Date: November 30, 2023
To: All Vendors
Subject: Addendum #2

**REFERENCE: B014-24 Re-Bid BPUB Downtown Wastewater Improvements-ARPA
Project 1**

Project:	Brownsville PUB – Downtown Wastewater Improvements ARPA Project 1 BPUB Bid No. B014-24	Addendum Date:	November 30, 2023
From:	Javier A. Esquivel, PE	Project No.:	BPUB2200025.01

ADDENDUM No. 2

SHEET
 CC02

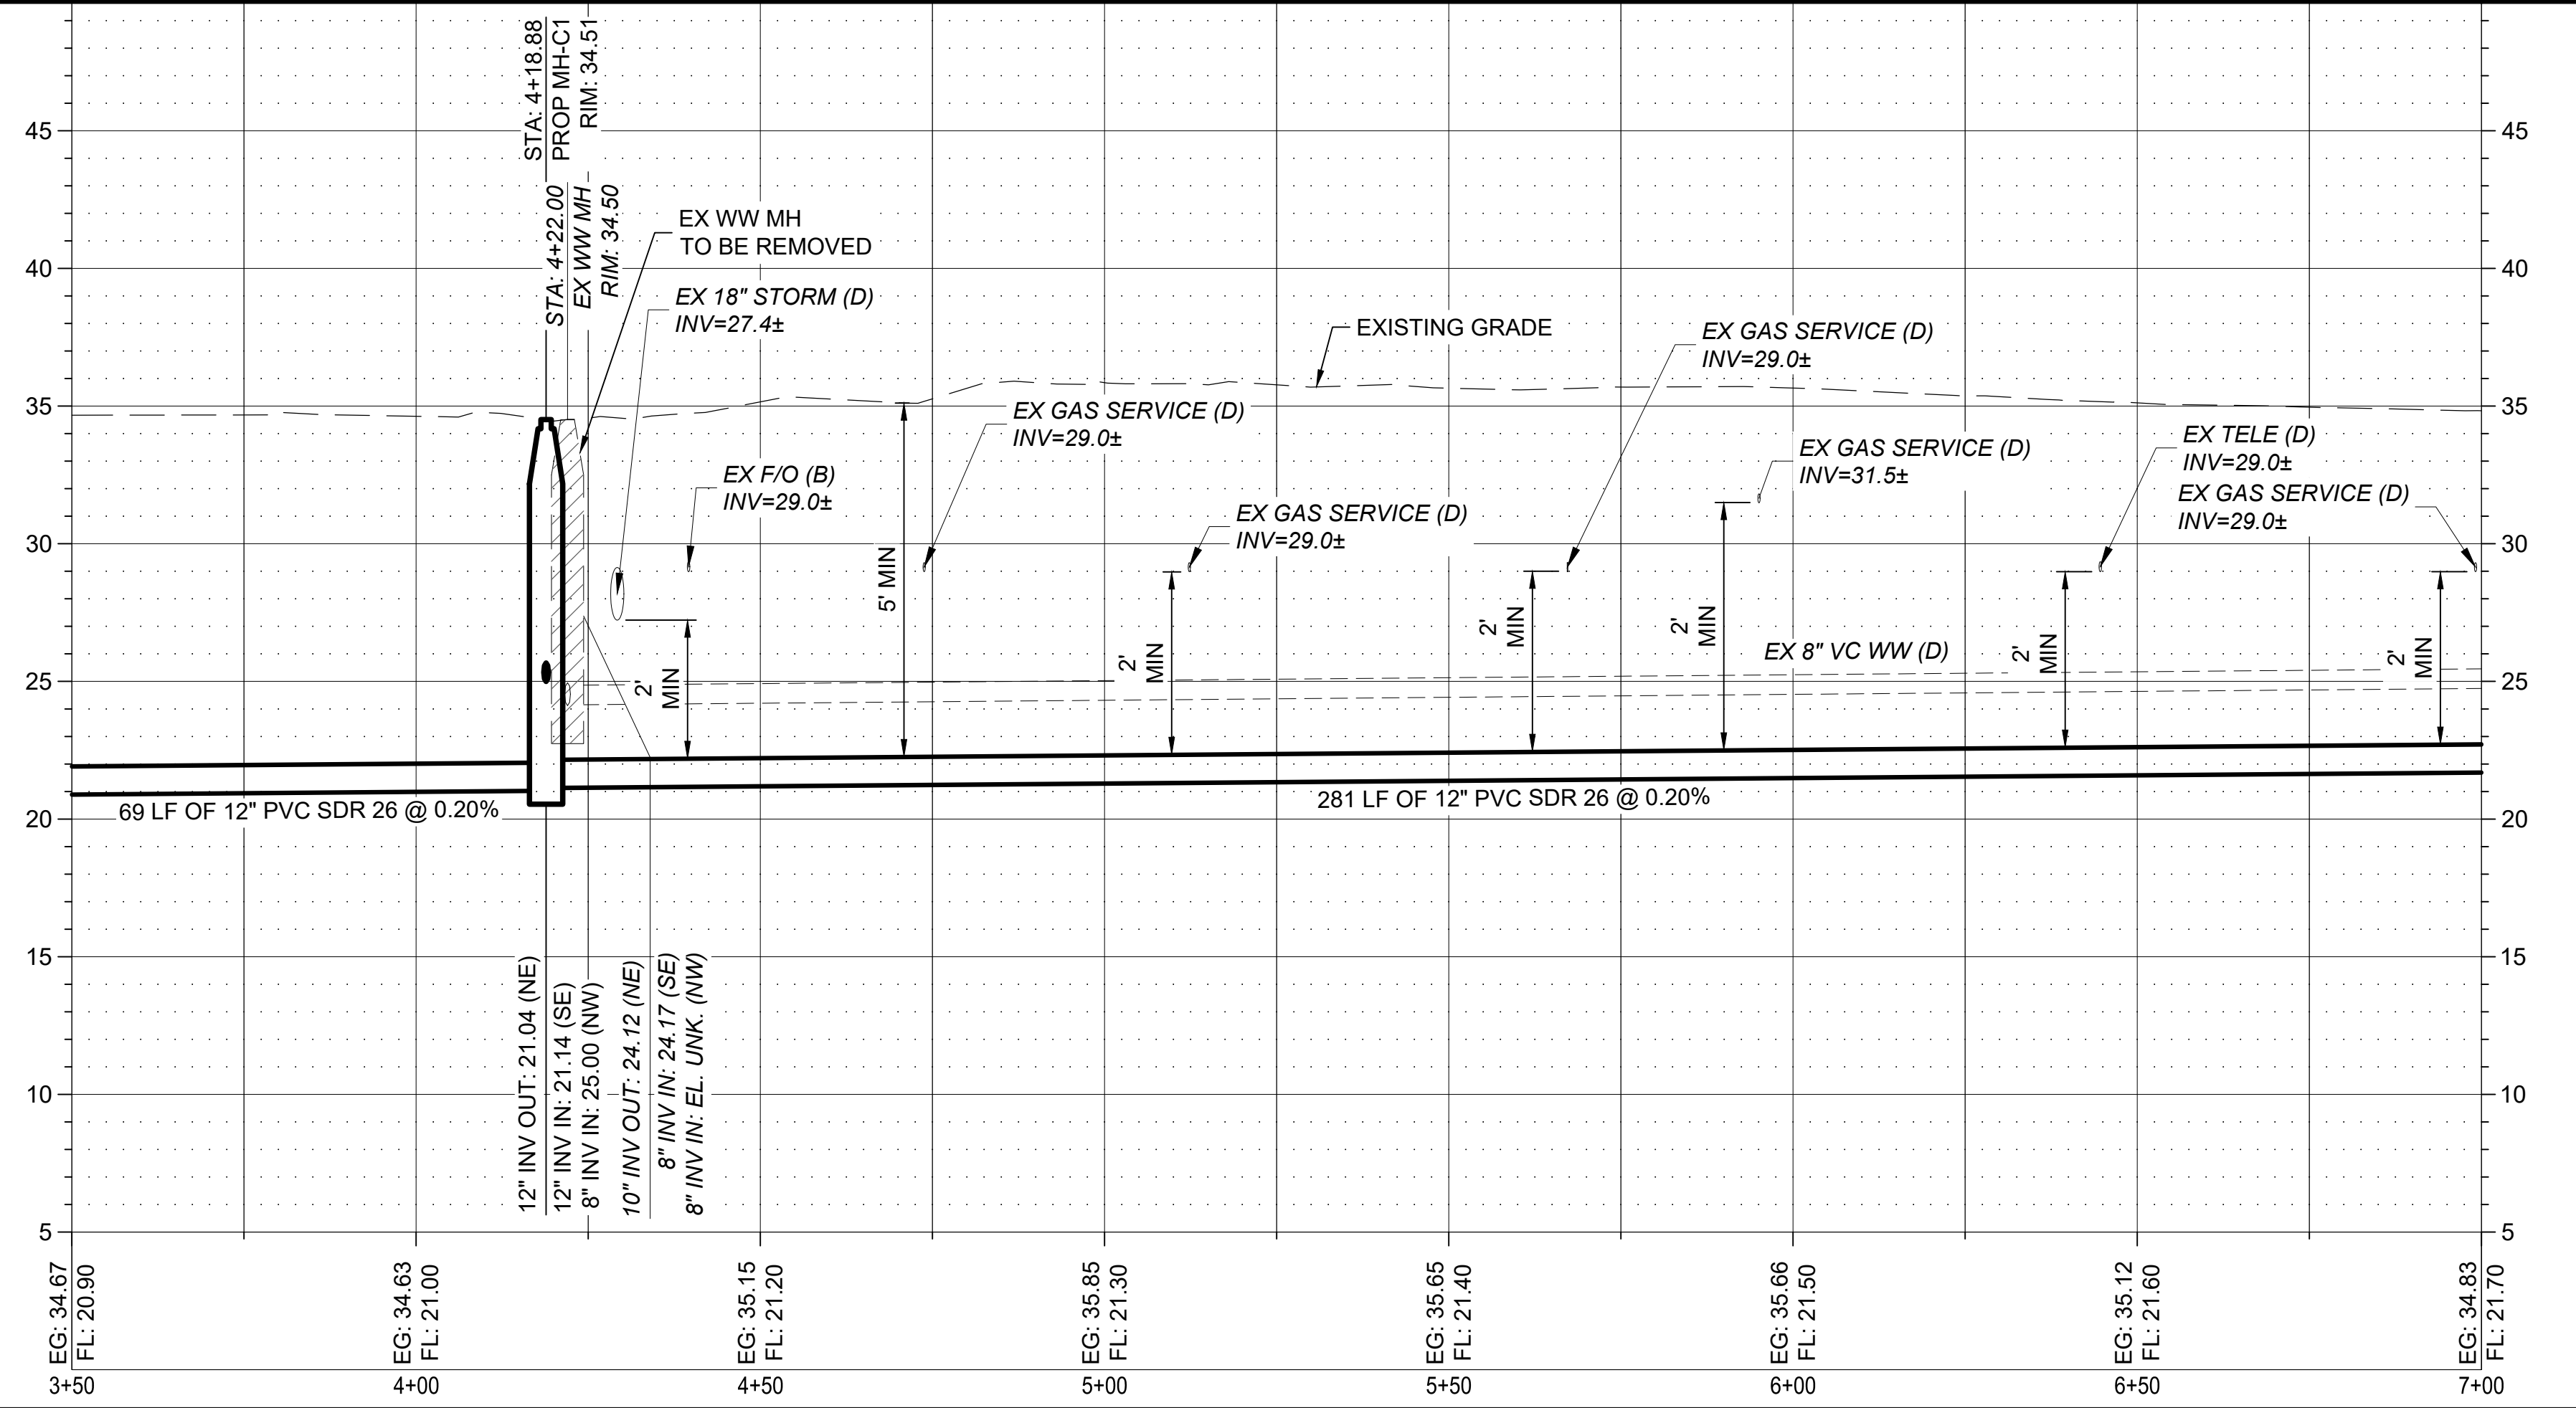
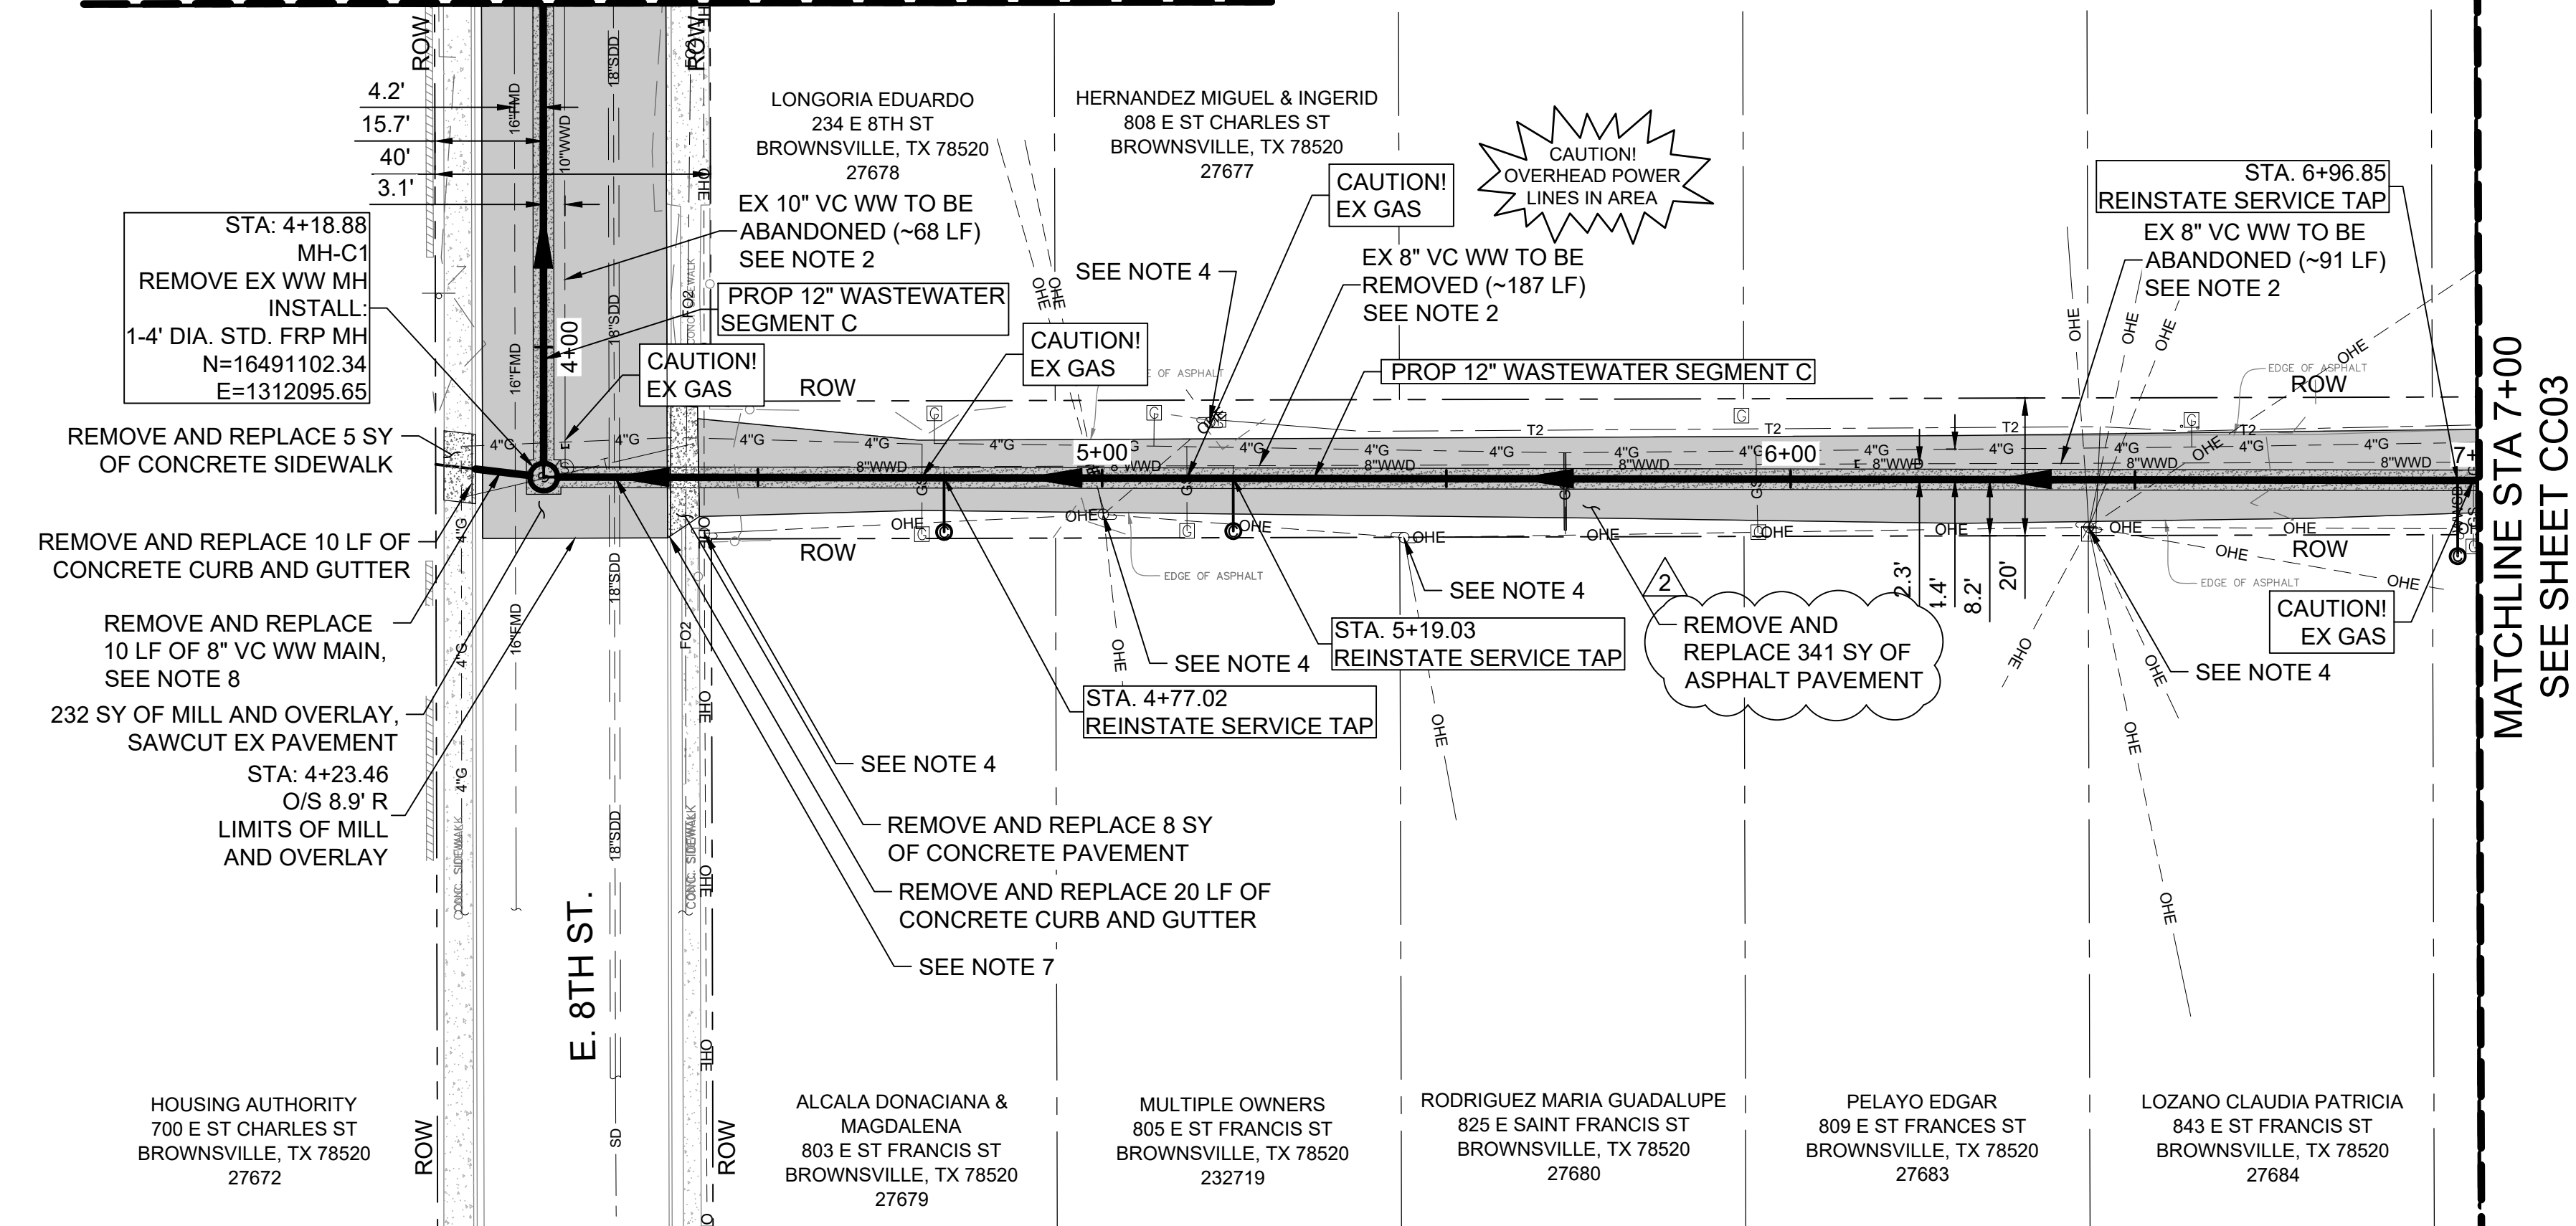
1. Revisions to Surface Restoration in the Alleys.
 - Segment A: Replace Mill and Overlay (2”) with full depth concrete asphalt pavement removal and replacement.
 - Segment B: Replace Mill and Overlay (2”) with full depth asphalt pavement removal and replacement.
 - Segment C: Replace Mill and Overlay (2”) with full depth asphalt pavement removal and replacement.

3. Plan Sheets: The following plan sheets were modified to update surface restorations CA02, CA03, CA04, CA05, CA06, CA07, CB01, CB02, CB03, CC02, CC03, CC04, and CC05.
